City of  
**Peterborough**

## Committee of Adjustment Report for March 28, 2023

Staff Recommendations Regarding Files: B02/23, A14/23, A15/23, A16/23, A17/23 and A18/23

## EXISTING SITE PLAN

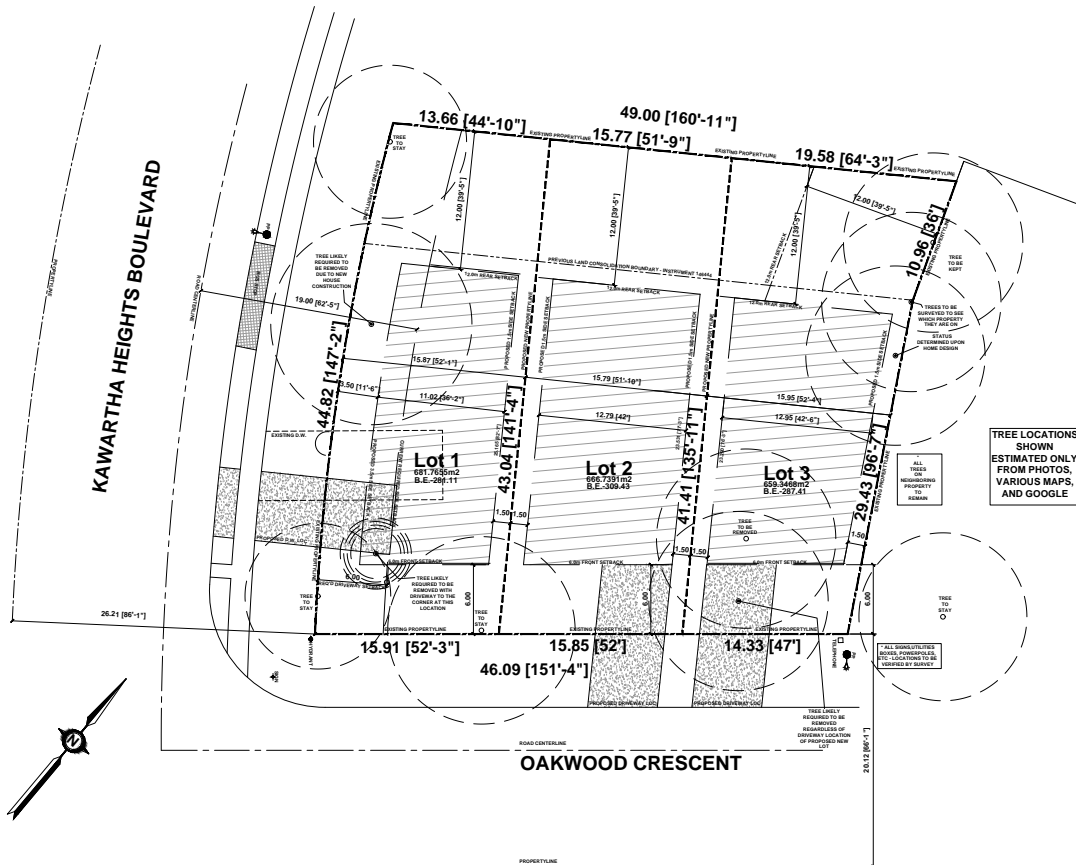
Through application B02/23, the applicant is seeking consent to sever two new building lots from the eastern portion of the subject property with frontage on Oakwood Crescent, as illustrated in the severance application drawing set provided by the applicant and attached as Exhibit A. The retained lands, which will be located at the corner of Kawartha Heights Boulevard and Oakwood Crescent, will have driveway access from Kawartha Heights Boulevard. To satisfy the requirements of the Zoning By-law, the applicant is also seeking minor variances for the two severed and retained lots through three separate applications, as follows:

The Proposed Severance Plan depicts the proposed boundaries and dimensions of each proposed lot as well as potential building envelopes and driveway access. Vehicle access to the retained lands will remain from Kawartha Heights Boulevard, while the two severed lots will gain vehicle access from Oakwood Crescent. To facilitate the creation of two new lots the applicant is proposing to remove the existing dwelling and all associated accessory structures from the property. The applicant is seeking relief from the minimum lot frontage, minimum lot area and minimum building setback from a side lot line for all lots. Although the proposed frontage, area and side yard setback is less than required by the Zoning By-law on this lot, the proposed parcel fabric and development standards will be similar to that of Kawartha Heights Boulevard to the north of the subject property and along Oakwood Crescent, east of 11 Oakwood Crescent (the neighbouring property).

Staff has reviewed the concept plans submitted by the applicant and has reviewed the request in the context of the surrounding area and the criteria under Sections 51(24) and 45(1) of the **Planning Act**. It is the opinion of staff that the consent application satisfies the criteria set out in Section 51(24). With regards to the minor variance applications, it is the opinion of staff that the requested variances maintain the general intent and purpose of the Zoning By-law and Official Plan, are minor in nature and are desirable for the appropriate development of the land.

Staff recommends that the Committee of Adjustment **approve** the application for consent conditional upon:

- i) Approval of Minor Variance Applications A14/23, A15/23 and A16/23 associated with the retained and severed lands;
- ii) Confirmation that the existing dwelling and all associated accessory buildings and structures on the property have been demolished or otherwise removed through the appropriate permits from the Building Division to the satisfaction of the Chief Building Official;

- iii) Payment of Tree Levy in the Amount of \$1,089.17, representing amounts of \$572.01 for Lot 2 and \$517.16 for Lot 3;
- iv) Payment of a Parks Levy in an amount to be determined by the Parks Levy Review Committee;

PROPOSED LOT 1 SCALE: 1:200

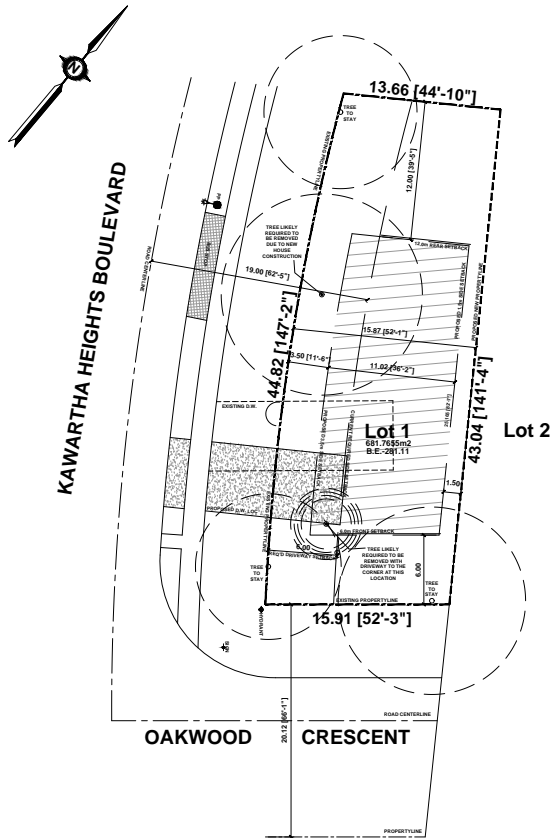
The applicant is seeking the following relief from the Zoning By-law to facilitate the creation of a new lot and building envelope for the retained lands (Lot 1 on the concept plan) resulting from application B02/23:

- Section 3.4.1(h) to reduce the minimum lot area from 695 square metres to 681 square metres;
  - Section 3.4.2(h) to reduce the minimum lot width from 22 metres to 15.9 metres;
- and

- iii) Section 3.4.8(d) to reduce the minimum building setback from the side lot line from 3 metres to 1.5 metres.

Staff recommends that the Committee of Adjustment **approve** the application conditional upon the submission of the Registered Transfer/Deed of Land related to File B02/23.

PROPOSED LOT 2 SCALE: 1:200

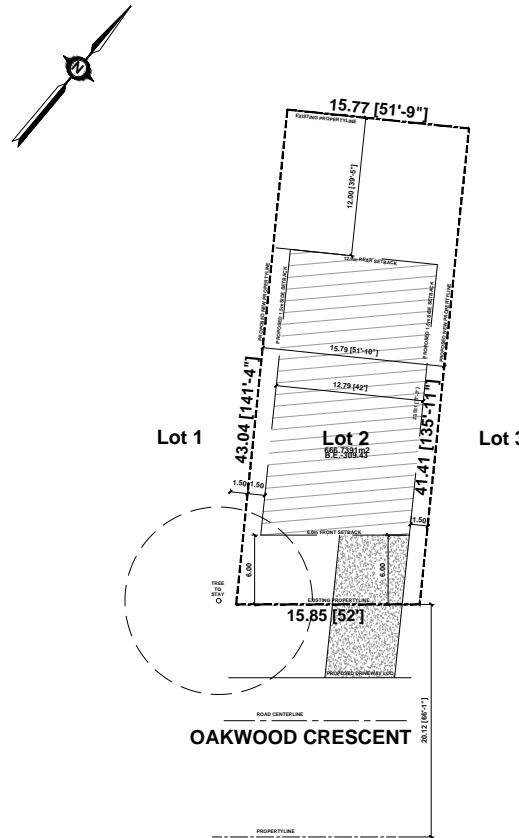
The applicant is seeking the following relief from the Zoning By-law to facilitate the creation of a new lot and building envelope for the severed lands (Lot 2 on the concept plan) resulting from application B02/23:

- i) Section 3.4.1(h) to reduce the minimum lot area from 695 square metres to 666 square metres;
- ii) Section 3.4.2(h) to reduce the minimum lot width from 22 metres to 15.8 metres; and
- iii) Section 3.4.8(d) to reduce the minimum building setback from the side lot line from 3 metres to 1.5 metres.

Staff recommends that the Committee of Adjustment **approve** the application conditional upon:

- i) Submission of the Registered Transfer/Deed of Land related to File B02/23, and
- ii) Confirmation from Peterborough Utilities Group of payment of any applicable Development and/or Frontage Charges.

PROPOSED LOT 3 SCALE: 1:200

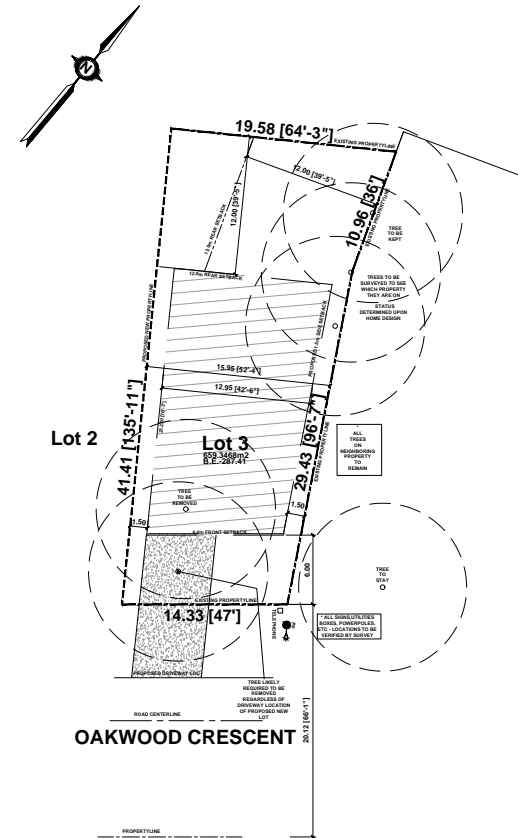
The applicant is seeking the following relief from the Zoning By-law to facilitate the creation of a new lot and building envelope for the severed lands (Lot 3 on the concept plan) resulting from application B02/23:

- i) Section 3.4.1(h) to reduce the minimum lot area from 695 square metres to 659 square metres;
- ii) Section 3.4.2(h) to reduce the minimum lot width from 22 metres to 14.3 metres; and
- iii) Section 3.4.8(d) to reduce the minimum building setback from the side lot line from 3 metres to 1.5 metres.

Staff recommends that the Committee of Adjustment **approve** the application conditional upon:

- i) Submission of the Registered Transfer/Deed of Land related to File B02/23, and
- ii) Confirmation from Peterborough Utilities Group of payment of any applicable Development and/or Frontage Charges.

**PROJECT NAME:**  
CORY CONDON  
459 KING GEORGE STREET  
PROPOSED SECONDARY SUITE  
**DRAWING NAME:**  
SITE PLANS &  
FIRE HYDRANT DISTANCE

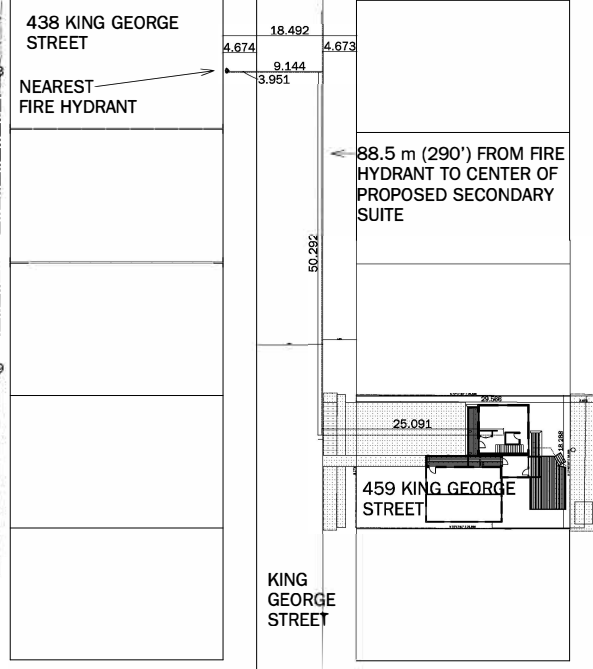
The applicant is proposing to construct a two-storey addition with a small rear deck, replacing the existing attached garage, as part of a comprehensive renovation of the subject property (Exhibit B). As part of this same application, the applicant is proposing to recognize the existing non-compliance that was introduced by the unpermitted construction of the existing rear deck. Aside from the rear deck, the existing dwelling and attached garage is considered legal non-complying with regards to the minimum required building setback from the rear yard and east side yard. The applicant is seeking the following variances from the Zoning By-law to facilitate the proposed construction and recognize the existing non-compliant condition:

- a) Section 7.2(e)(ii) to reduce the minimum building setback from a rear lot line from 7.6 metres to 5.4 metres;
- b) Section 6.19(b) to increase the projection of a platform into the rear yard setback from 3 metres to 7.1 metres to recognize the location of the existing unpermitted platform; and
- c) Section 6.19(b) to increase the projection of a platform into the rear yard setback from 3 metres to 4 metres to facilitate the construction of a platform associated with the proposed addition.

The Planning, Development and Urban Design Division – Development Engineering Section has requested that a lot grading and drainage plan be required as a condition of approval.

The Urban Forestry Division notes that there is an existing private tree located at the rear of the property that may be impacted by the proposed construction. The applicant is required to obtain a tree removal/injury permit from the Urban Forestry department. The removal/injury of trees of any size are regulated by Tree By-law 21-074. Tree replacement

will be required on the subject property. An existing tree on adjacent City property must be retained and will require tree protection measures and fencing to be installed according to the City's Tree Protection Fencing Specification.

Staff recommends that the Committee of Adjustment **approve** the application provided that the construction related to this approval proceed substantially in accordance with the concept plans attached as Exhibit B and conditional upon:

- i) The completion of a lot grading and drainage plan to the satisfaction of the Supervisor of Development Engineering;
- ii) Obtaining a tree removal/injury permit from the Urban Forestry Division or providing written comment from Urban Forestry that a permit is not required; and
- iii) Submission of a Tree Protection Plan to the satisfaction of the Urban Forestry Division, prior to the issuance of a building permit.
